Introduction

360°RF has been retained to perform a design review and electrical/RF testing of a proposed Zigbee module, shown to the right. This report presents our conclusions and suggested modifications to the proposed design.

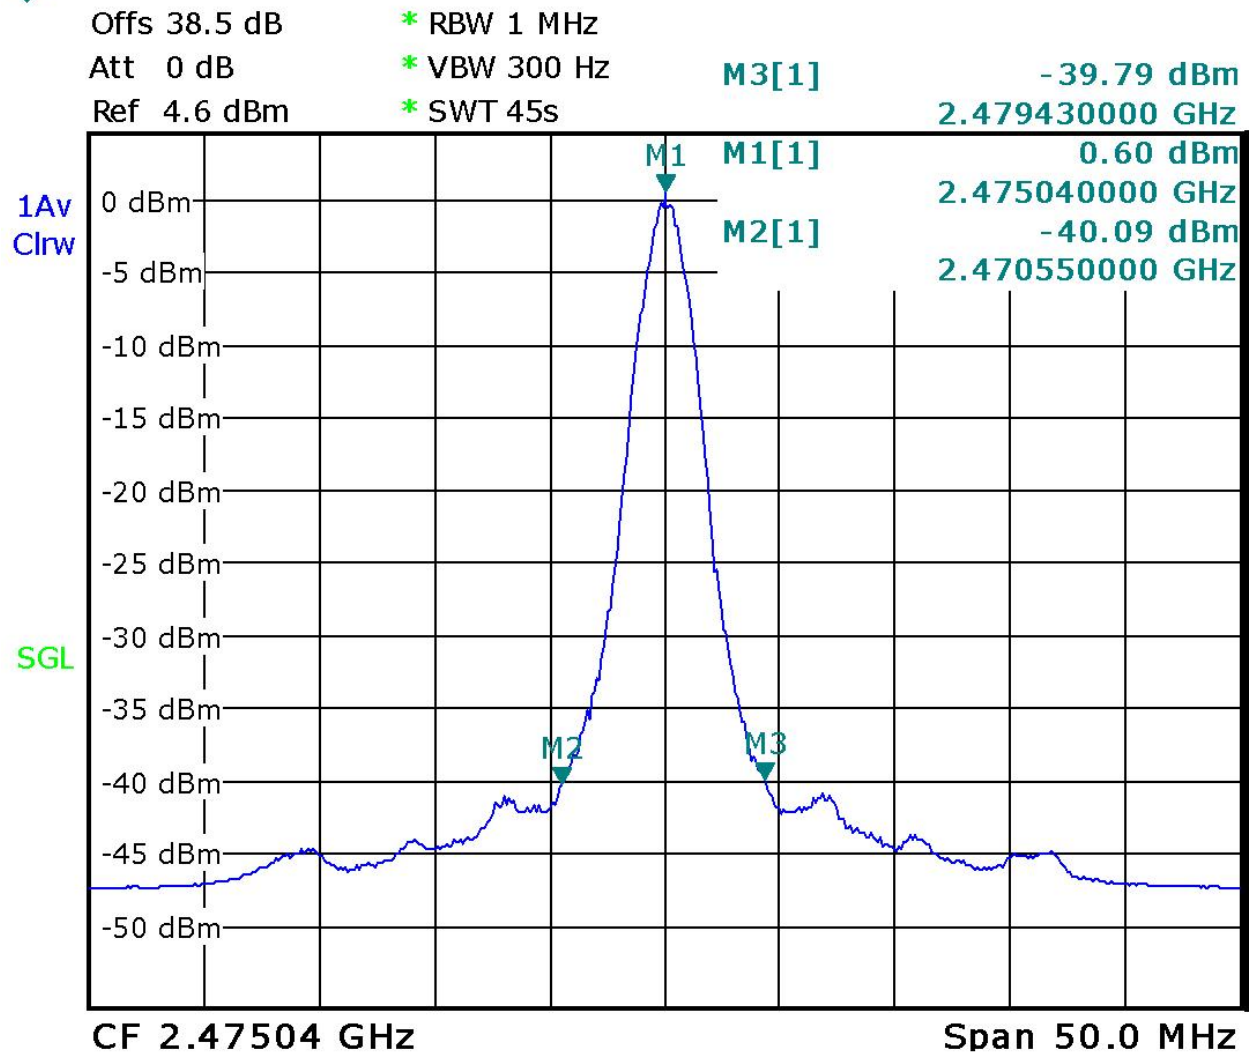
This product has an unusually well-done antenna design compared to typical 2.4 GHz products. The antenna is an 'Inverted F' with artwork on both the top and bottom layers of the PC board. Placing copper on both the top and bottom layers greatly reduces the dielectric effects of the fiberglass. Thus, variations in the ϵ_r (dielectric constant of the PCB material) will have little effect on the tuning of the antenna.

Both the lengths of the F, and the matching section, were adjusted. Improvements, if any, were just a few tens of a dB, and well within measurement uncertainties. The antenna is on frequency and impedance-matched; no change to the antenna is necessary.

Plot of Occupied Bandwidth. The signal is just under 10 MHz wide at the - 40 dB points. Note that there are no obvious VCO artifacts such as sidebands or spurious emissions.

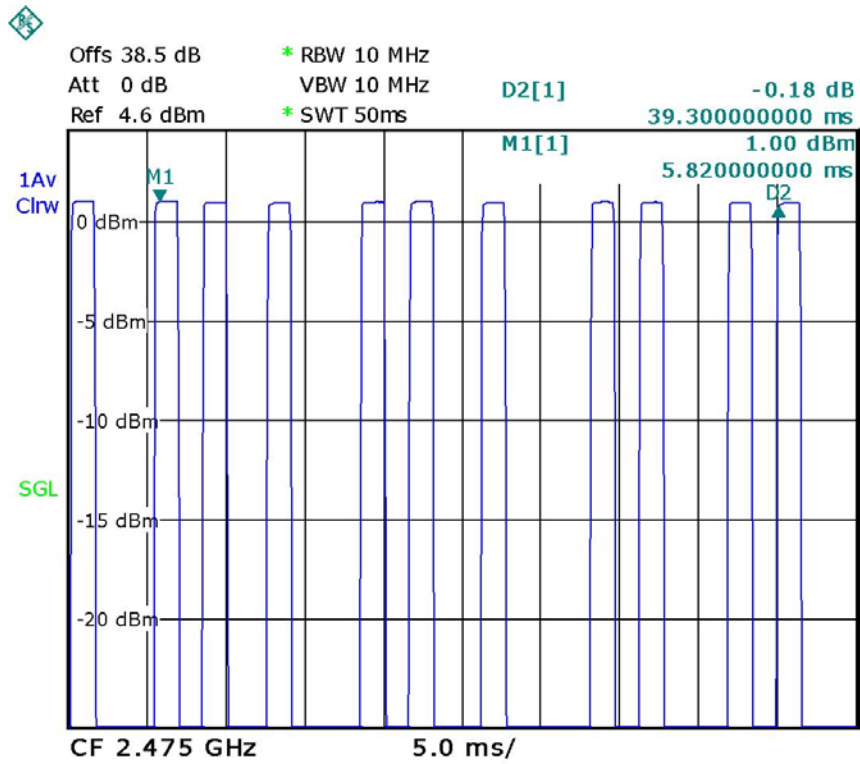
The -40 dB bandwidth is just under 10 MHz, as shown in the plot on the next page. There may be issues with the FCC if the planned channel assignments are within 5 MHz of the band edges; i.e., the center of the channel should not be below 2407 MHz or above 2477 MHz, unless the duty cycle is kept very short.

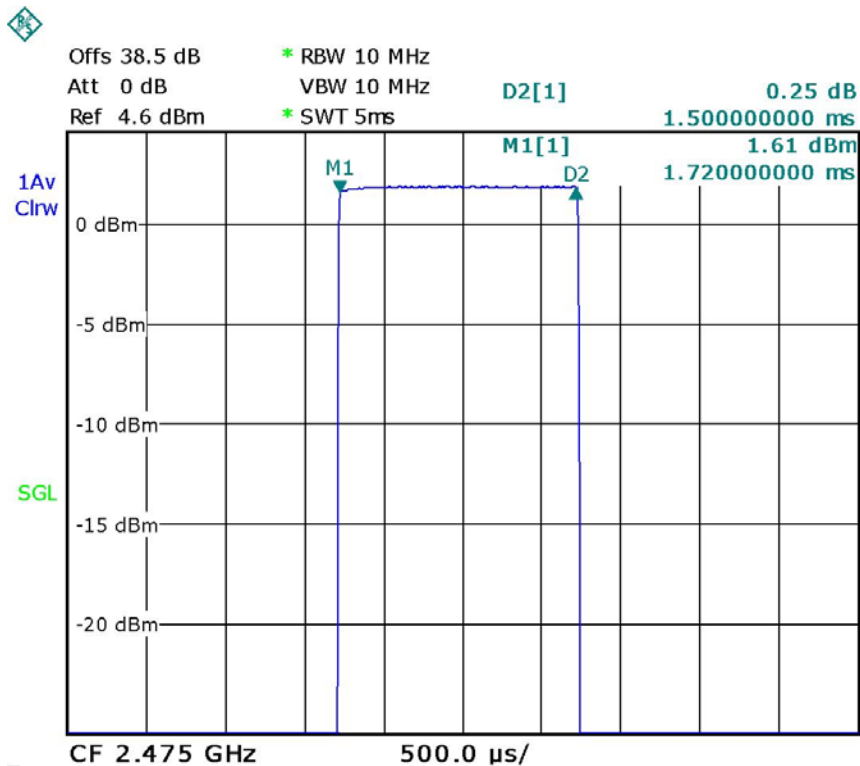
The FCC compliance lab will look at the unit duty cycle for both a Screamer and a typical unit. The data packets were 1.5 mS long. The Screamer generated 9 packets 1.5 mS long during a 39.3 mS period. This gives a duty cycle for the Screamer of 13.5/39.3 or approximately 34%. These measurements are shown on plots on the following pages.

The plot above shows the time period for 9 packets to be about 39.3 milliseconds, while the plot below shows the pulsewidth of a packet to be about 1.5 milliseconds. Thus, the calculated duty cycle of the Screamer is about 34%.

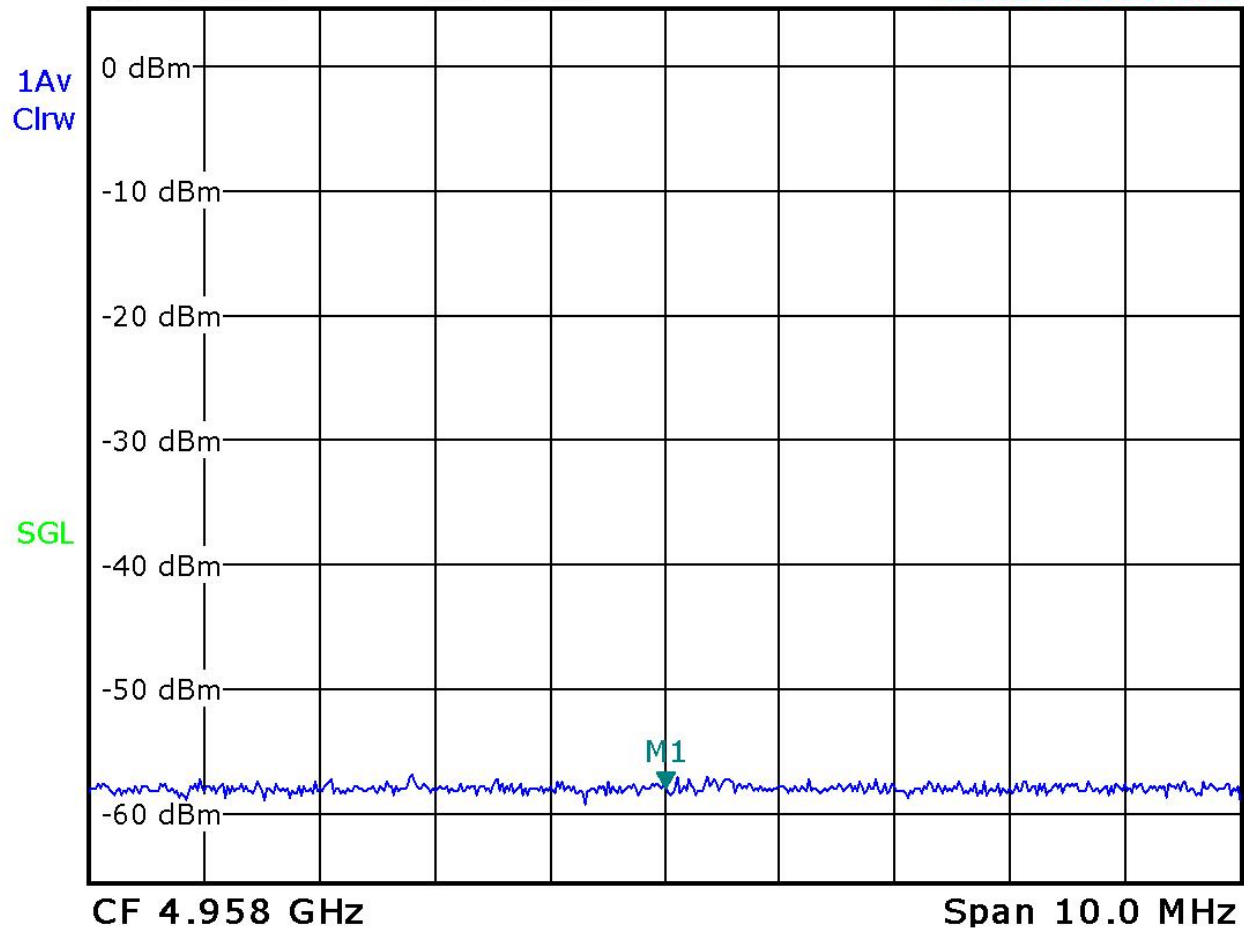
Between 100 MHz and 18 GHz, no unusual emissions were detected; the second harmonic was virtually undetectable. This is quite unusual for the typical 2.4 GHz product. All harmonics up through the 6th were at least -59 dBc.

The second harmonic is at least -57.9 dB down from the fundamental average level.
